## The proposed extent of demolition and proposed works for the ERB and Energy Centre Programme planning applications

Pre-application Meeting 3: March 2023

A third pre-application meeting was held with both LB Camden and HE Officers on the 2nd March 2023. This meeting did not heavily feature the SWEC or ISS proposals as it was focused on closing out matters related to the advanced submission of the ERB part of the transition programme, which was submitted shortly after in April of 2023.

Existing and proposed preliminary daylight and sunlight analysis for the SWEC site completed by GIA as shared with LB Camden in December of 2022

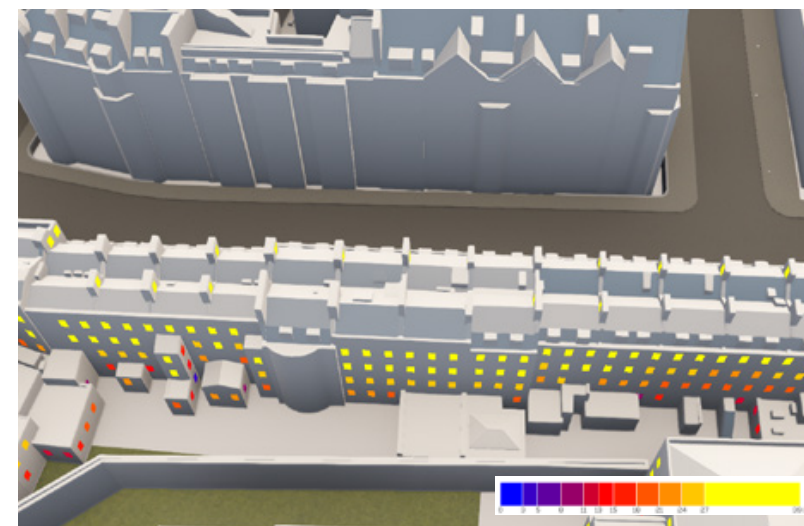
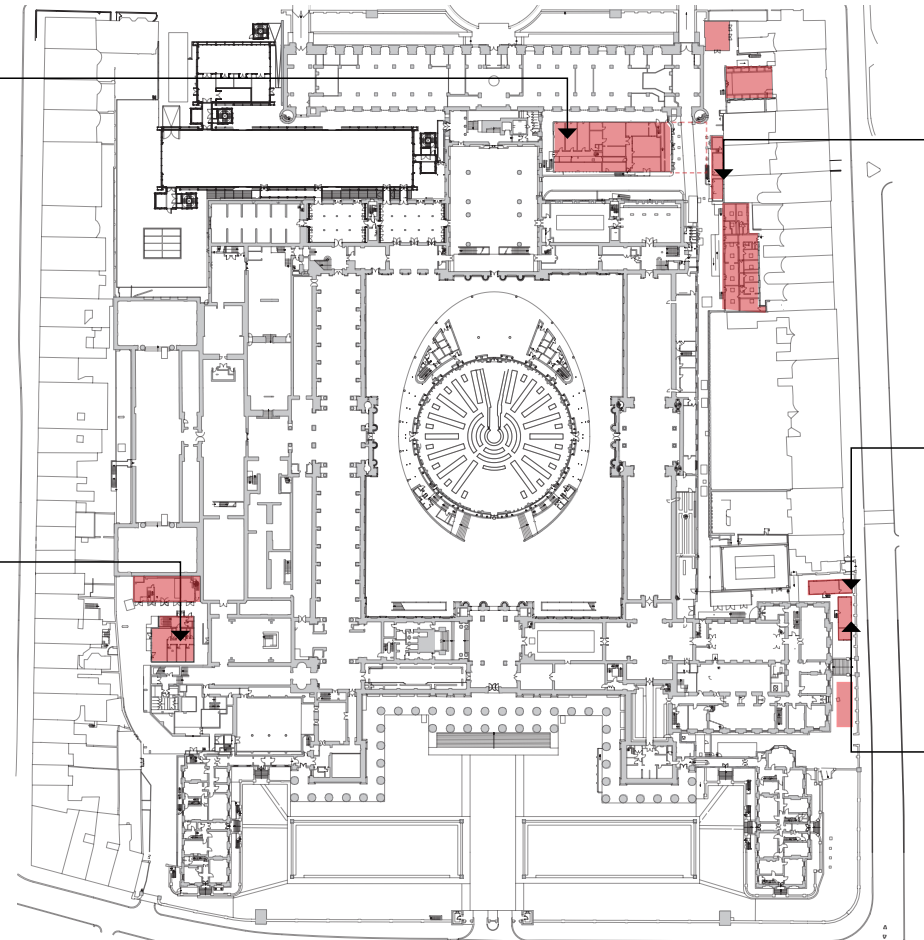
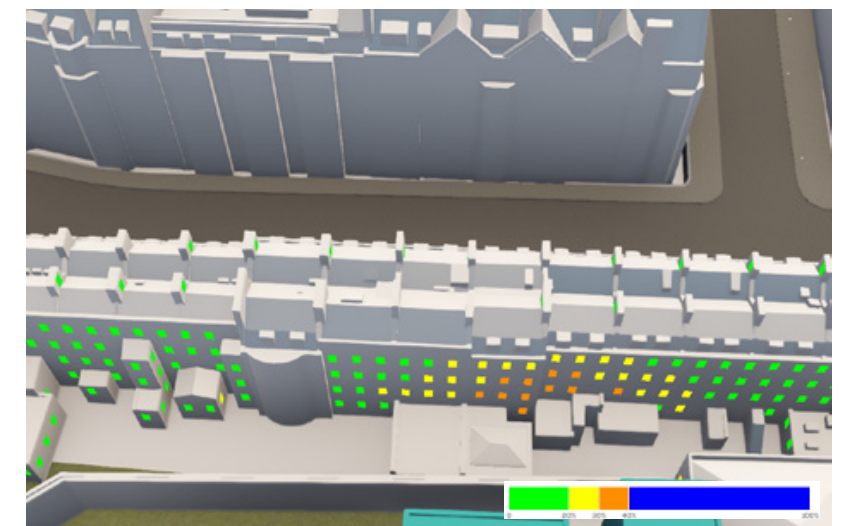
Officer’s also requested information with regards to demolition and proposed sections and daylight and sunlight analysis for the SWEC building. The project team referenced information to date had been provided within the technical pack submitted following preapplication 2 covering both daylight and sunlight as well as existing, demolition, and proposed plans, sections and elevations for all sites. Please refer relevant sections of this document as well as the Sunlight Daylight Assessment and Application Drawings submitted within the application documents for up to date information with regards to these aspects of the proposals.

In response to Officer comment regarding consideration to be given to neighbouring listed properties, further specialist analysis by Daylight/Sunlight consultant Gordon Ingram Associates was undertaken and presented to Officers at Preapplication Meeting 2. Further information with regards to neighbouring amenity is provided in Chapter 1 of this report and within GIA's report submitted as part of the application documents. In summary, the analysis did not suggest making any massing alterations with respect to daylight and sunlight to adjacent properties, which are of Hotel and Commercial use.

Key plan and enlarged plan showing the requirements for increased or new basement services trenches in the South basement corridor as presented with LB Camden in December of 2022

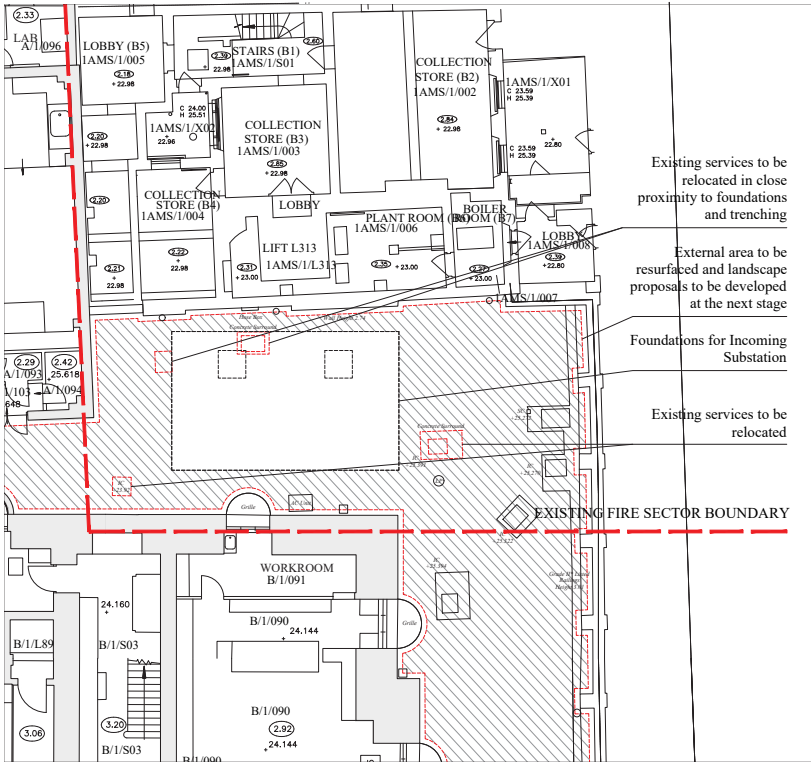
Officers also asked for further detail regarding the heating systems technical detail. The two stage system based on the use of air and water source heat pumps was described verbally by the project team, and further detail was provided in the technical pack noted above that was issued following the meeting. Please refer to chapter 4 of this document and the Energy Statement for further information.

- A site wide description of the distribution required from new primary plant to secondary plant around the estate. This included an area by area illustration of where existing fabric removal was required within existing basement levels to accommodate the new larger and insulated low temperature hot water pipework and electrical cabling.
